DOCUMENT 00 9010
ADDENDUM NUMBER 01

DATE: **October 6,2022**
PROJECT: SE Branch Library Parking Lot Replacement
PROJECT NUMBER: PJ000106
OWNER: City of Arlington
ARCHITECT: Simon Engineering & Consulting, Inc.
 15443 Knox Trail Drive, Suite 140
 Dallas, TX
 Ph: (214) 884-2056
TO: Prospective Bidders

**CITY OF ARLINGTON
SE BRANCH LIBRARY PARKING LOT REPLACEMENT
QUANTITY SUMMARY**

CITY OF ARLINGTON, TEXAS
 ARLINGTON PUBLIC LIBRARY SOUTHEAST BRANCH
DRAINAGE PLAN
 900 SE GREEN OAKS BLVD, ARLINGTON, TX 76018
 DATE: 08/12/2022 SCALE: AS SHOWN SHEET 6 OF 15
 DESIGNED BY: VVS DRAWN BY: RAK CHECKED BY: YO

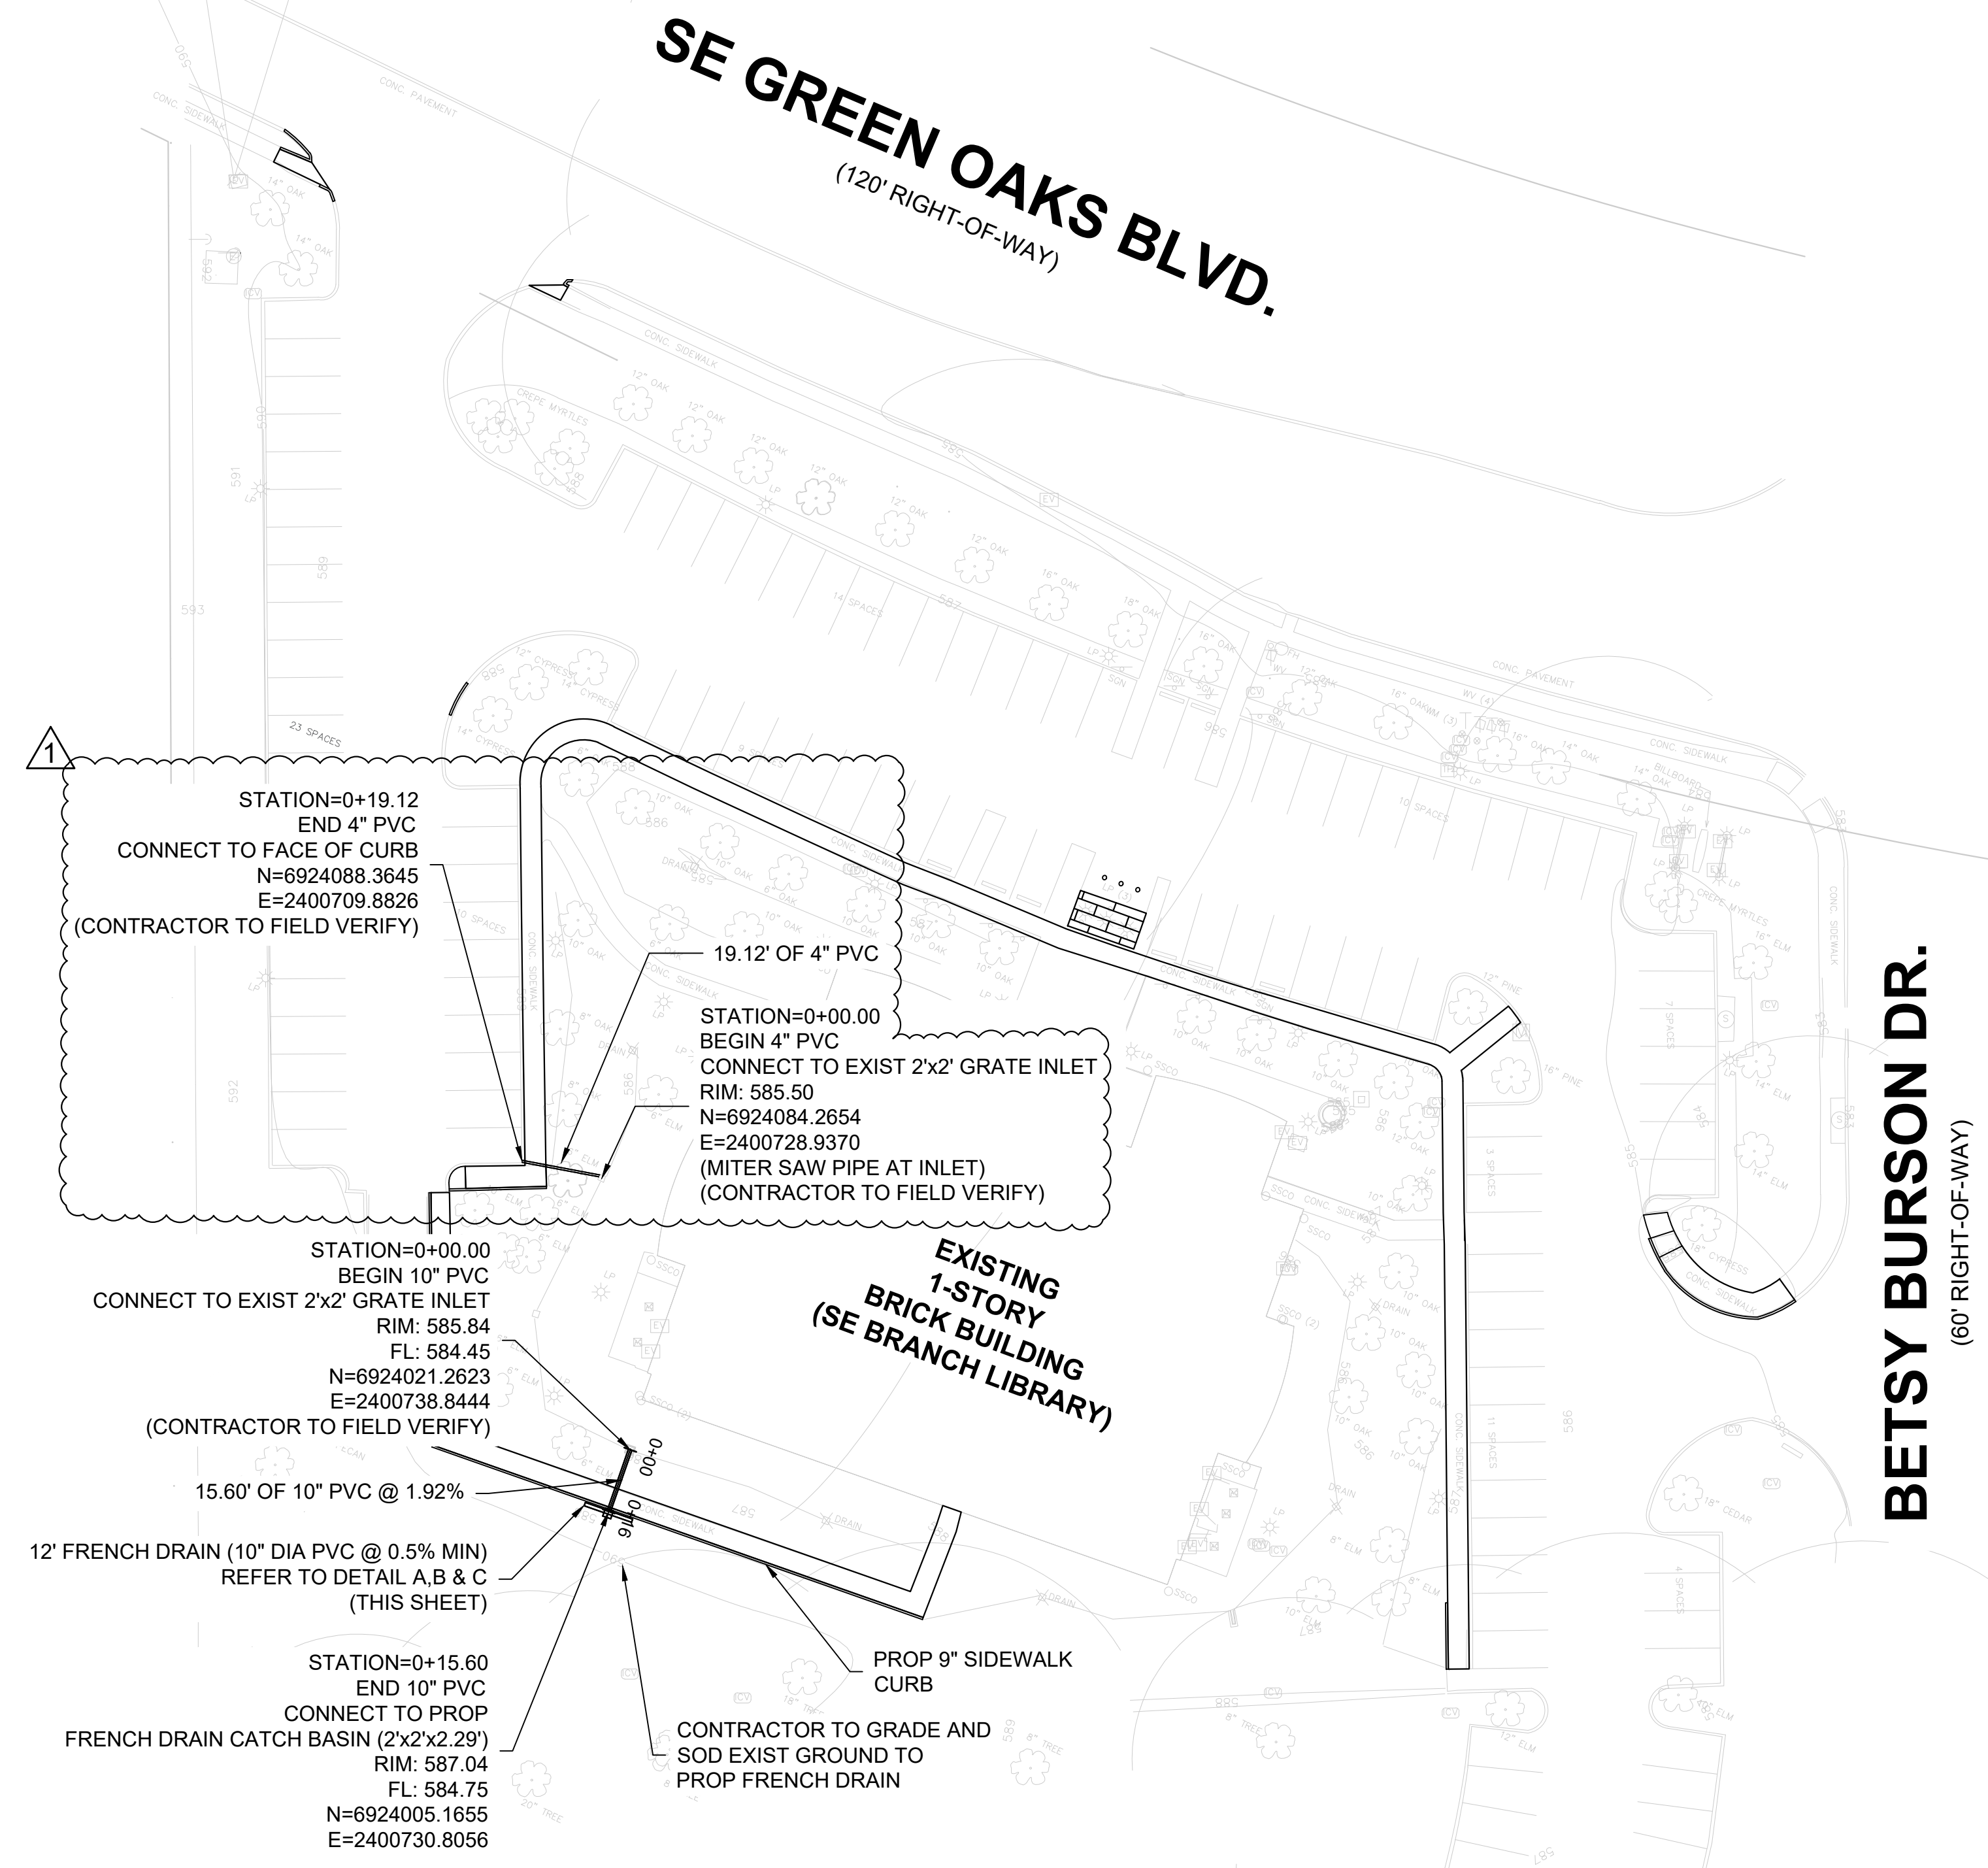
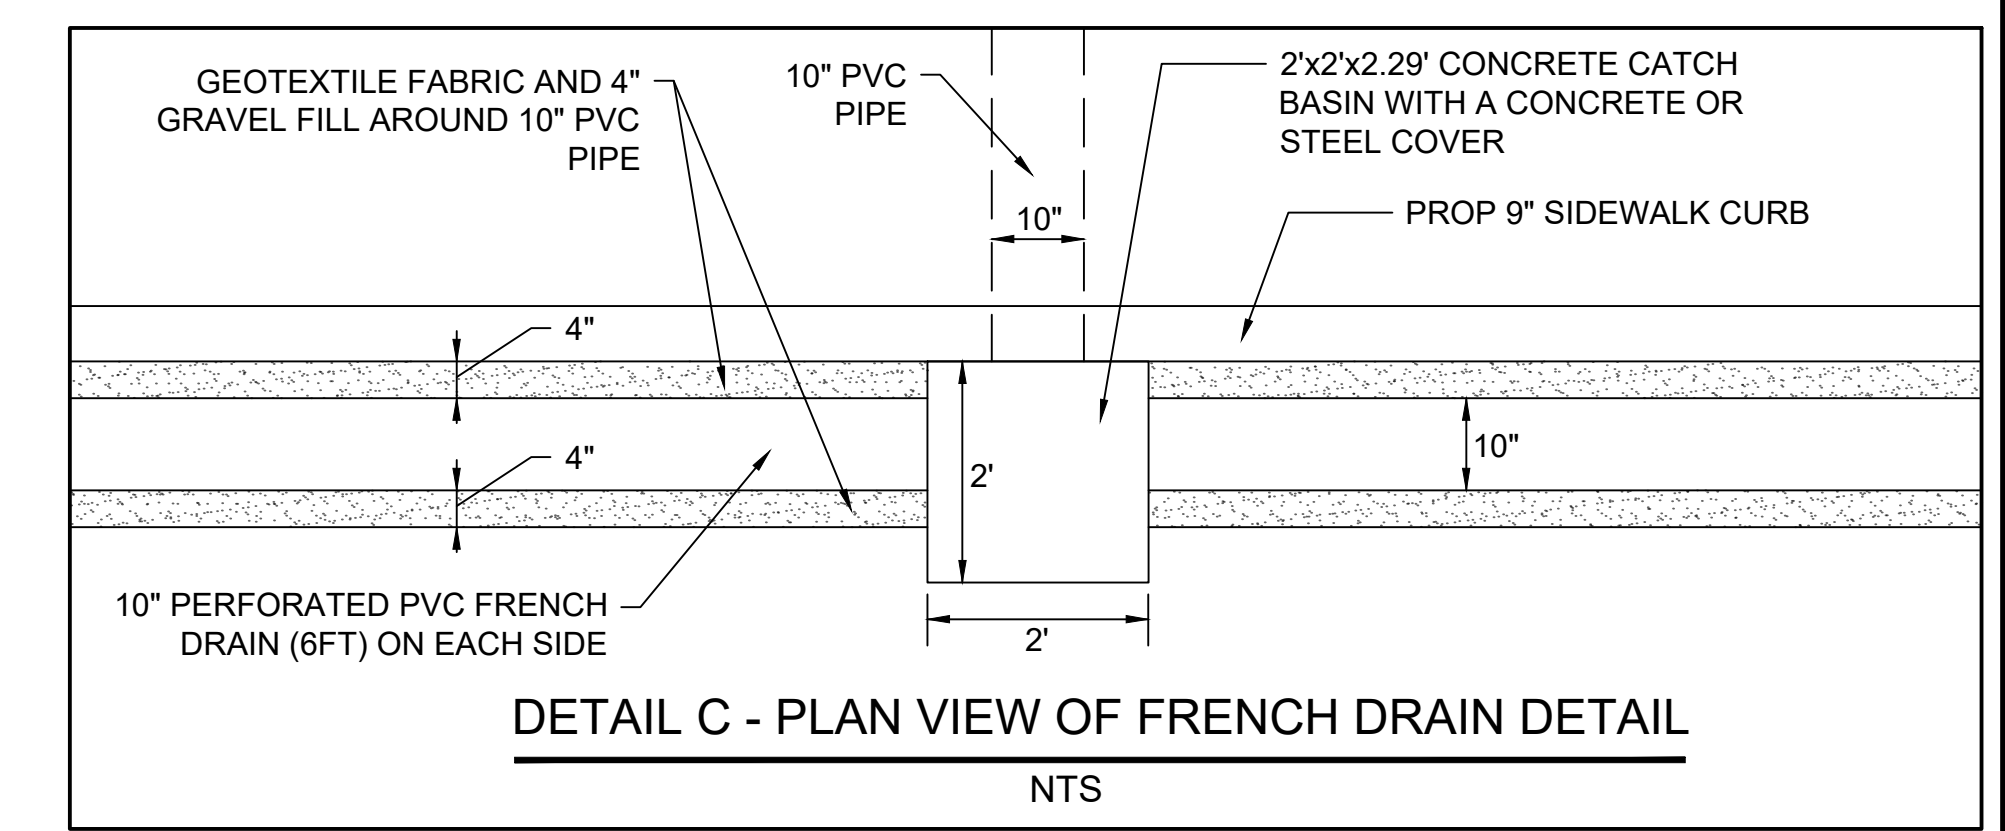
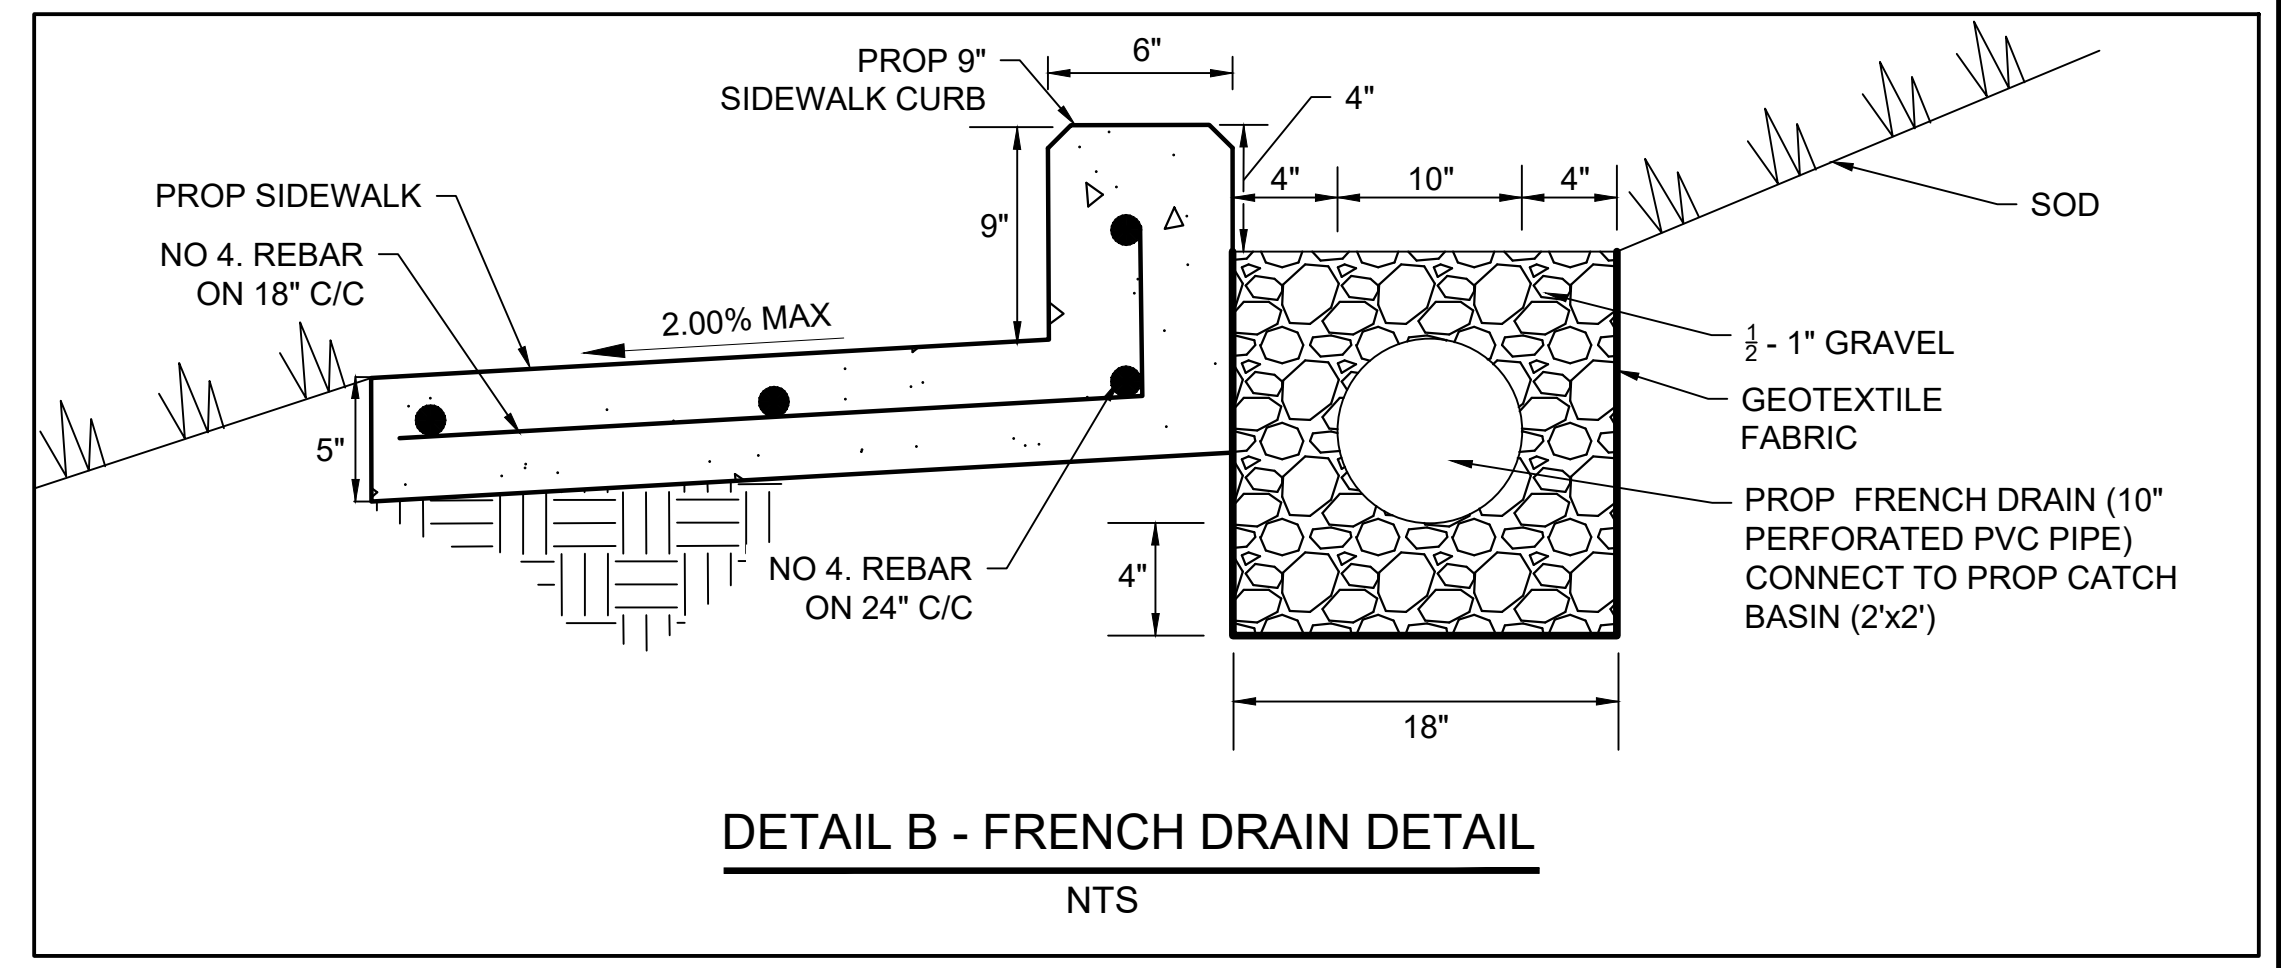
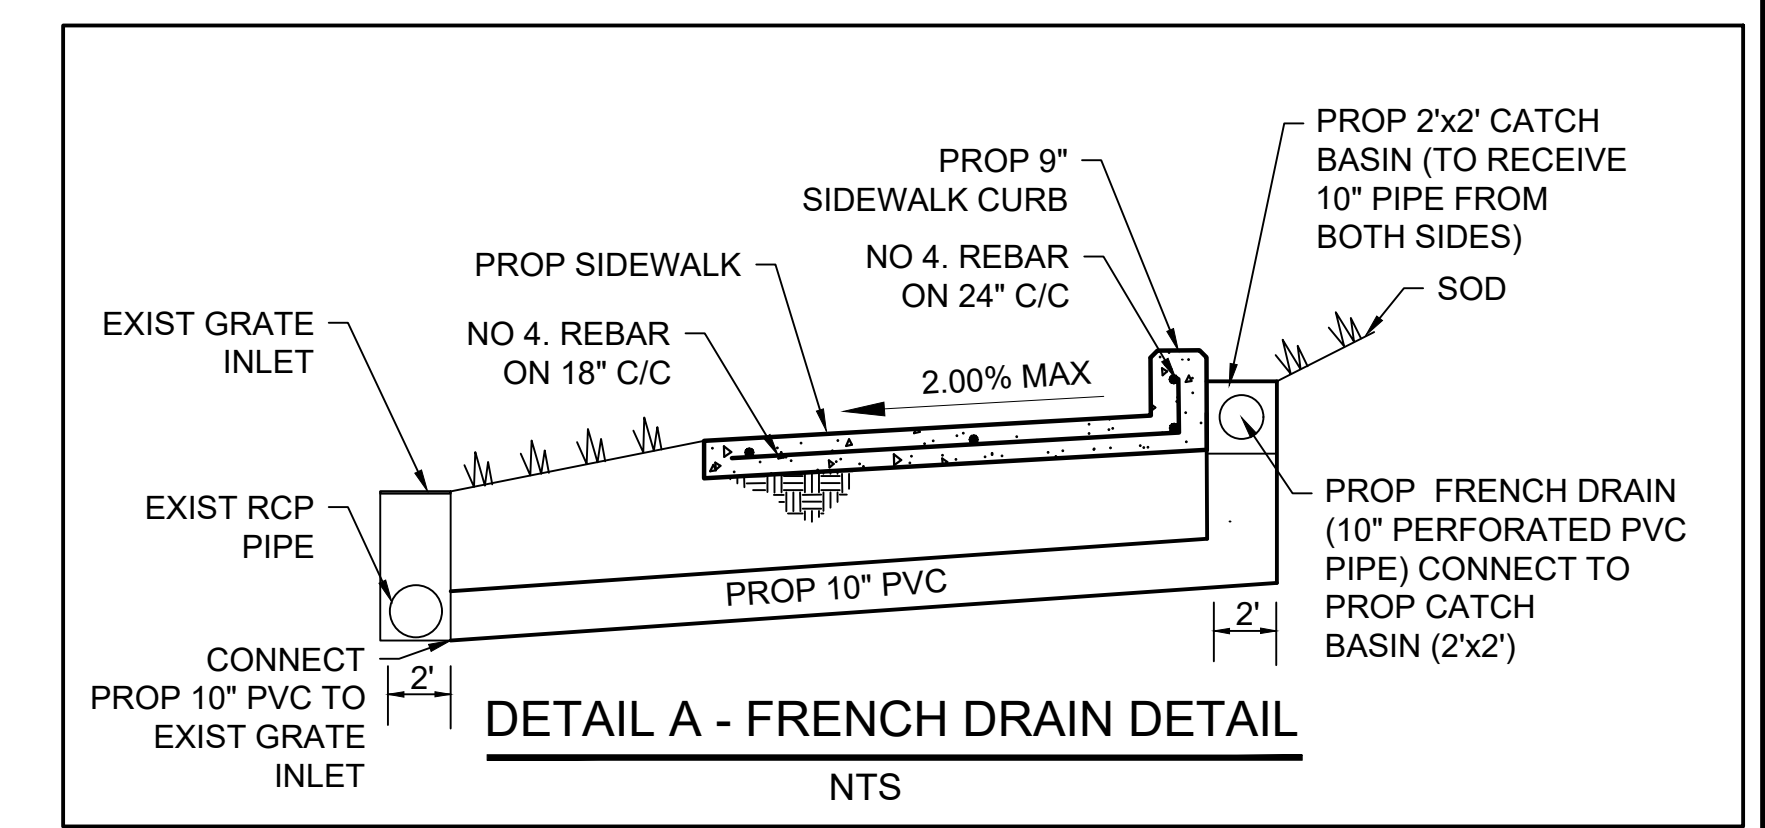
1. The detail changes to the drawings are shown in clouds with Rev 1 annotation. Brief description of the changes /removals or additions to Bid items are as follows refer to each drawings dated Rev 1 10/05/2022 for detail instructions .
 - a. Item 481 4” pvc pipe is added
 - b. Item 483 Milling Concrete slab is removed
 - c. Item 528 description changed
 - d. Item 531 Quantities increased,
 - e. Item 713 description and quantity is changed.

| No. | Date | Revisions |
|-----|------------|------------------|
| 1 | 10/05/2022 | ADDITIONAL 6\"/> |
